C-17 LANDING-GEAR DURABILITY AND PARTS SUPPORT

Report No. 99-193

June 24, 1999

SUBJECT: Audit Report on C-17 Landing-Gear Durability and Parts Support  
(Report No. 99-193)

Figure B-2. Aft Main Landing-Gear Test Schedule

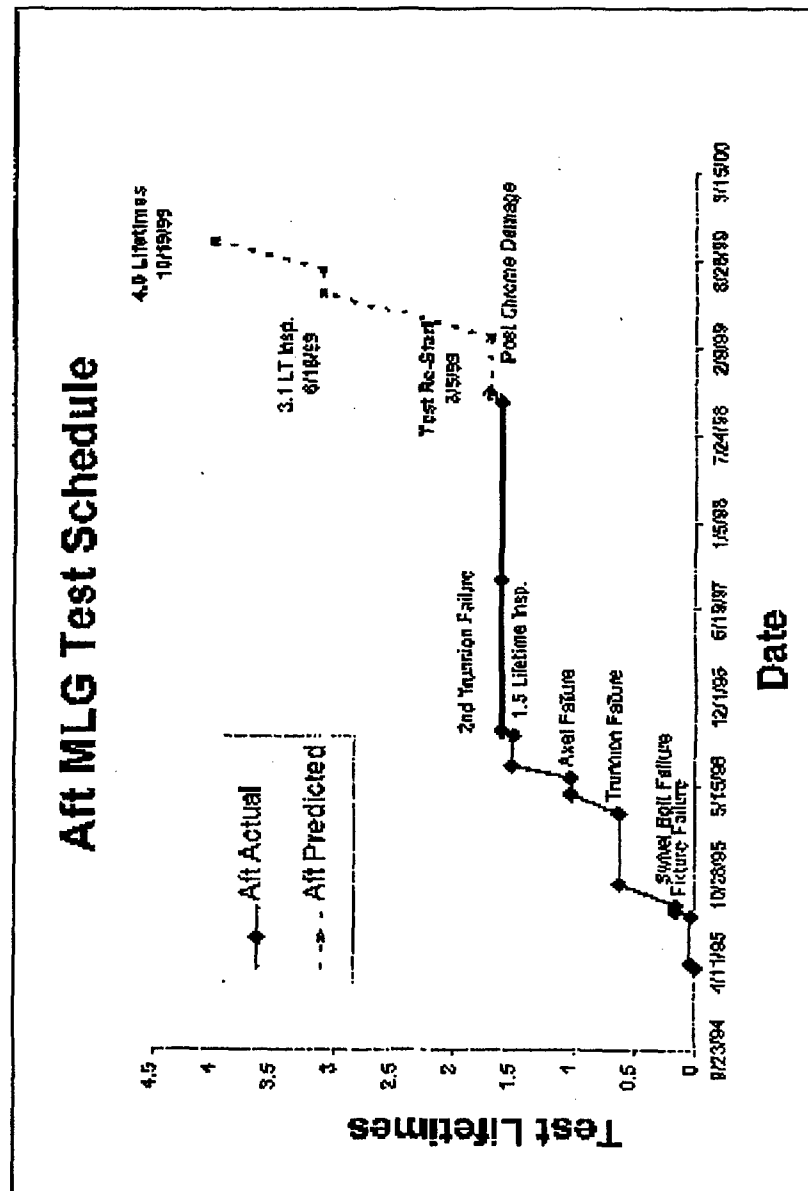
The results of durability tests on the nose and main landing gear components are shown in Appendix B. Appendix B, Figure B-2, shows that the aft main landing-gear trunnion collar initially failed at 0.63 lifetimes. After replacing that trunnion collar with a redesigned trunnion collar, durability testing resumed and the aft main landing gear trunnion collar failed again at 1.60 lifetimes. The trunnion design was redesigned and is undergoing durability testing. Appendix B, Figure B-3, shows that the forward main landing gear trunnion collar initially failed at 0.045 lifetimes. A redesigned trunnion collar was installed and reached 1.0 lifetimes of durability testing on October 21, 1998.

The aft main landing-gear trunnion collar failed at 0.63 lifetimes and was subsequently redesigned. The redesigned aft trunnion was installed in the test fixture, and testing resumed. The redesigned aft trunnion collar failed at 1.60 lifetimes. Accounting for the scatter factor of four, the failure corresponds to an actual life of 0.40. Testing of the aft landing gear was on hold for 2 years because of post redesign.

(4<sup>th</sup> paragraph, 3<sup>rd</sup> sentence) The trunnion collar that failed at 1.60 lifetimes was a redesigned trunnion collar, not an identical one. This fact is correctly stated in Appendix B.

Figure B-3. Forward Main Landing-Gear Test Schedule

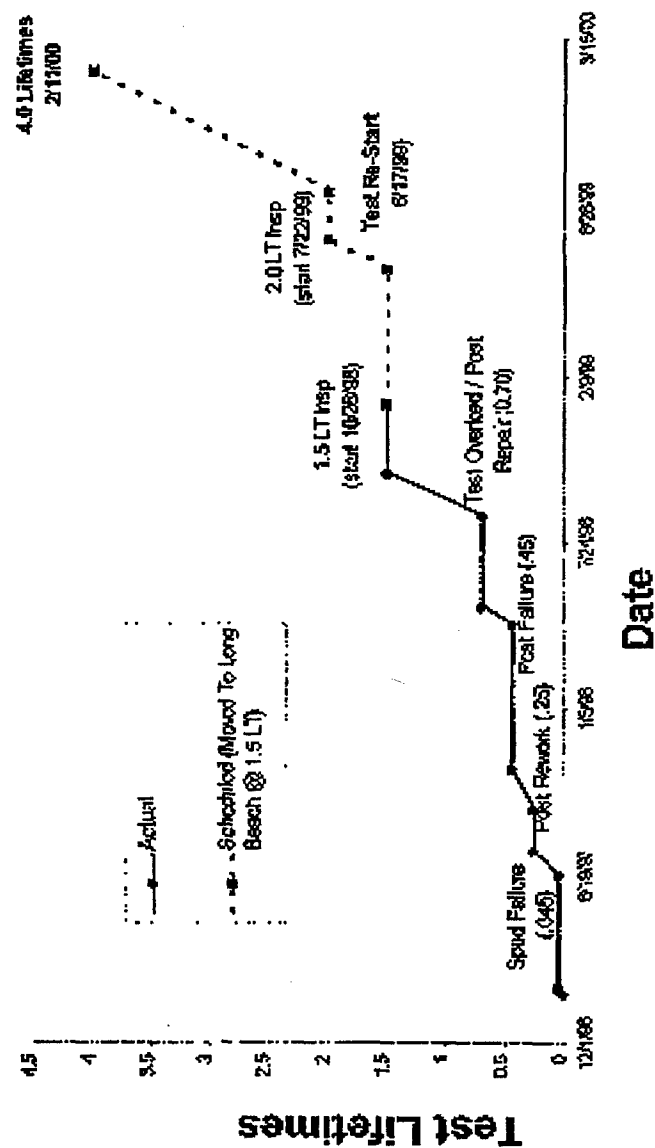
The forward and aft main landing-gear trunnion collars had repeated failures during durability testing, as shown in Figures B-2 and B-3. The trunnion collar and post are depicted in Figure B-4.

The forward main landing-gear trunnion failed at 0.045 lifetimes of test and was subsequently redesigned. The redesigned forward trunnion was installed in the test fixture, and testing resumed. Testing of the redesigned forward trunnion had reached 1.0 lifetimes in durability testing on October 21, 1998. Further testing of the forward trunnion will resume in the summer of 1999.

# C-17 MLG BRAKES

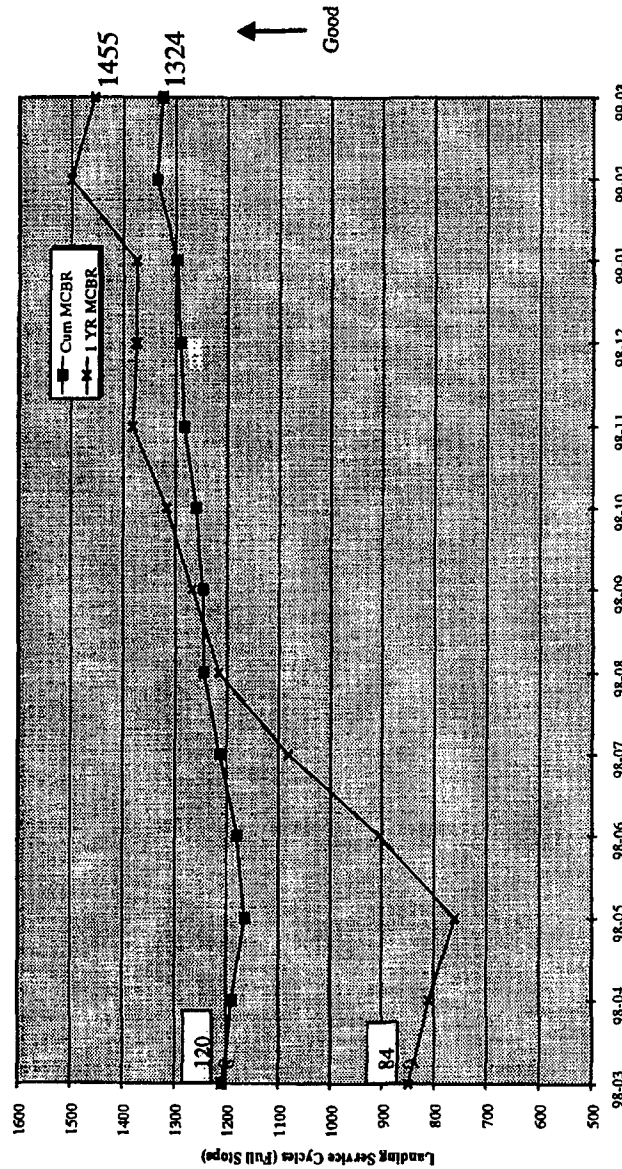
(1<sup>st</sup> sentence) Brakes are experiencing higher usage than identified in the Boeing procurement specification. However, the usage is in line with the Air Vehicle Specification, which is our baseline for weapon system performance.

Recommendation 3: The process of investigating costs and benefits of a new brake design has already begun. The contractor has received proposals for new brake designs from its vendors.
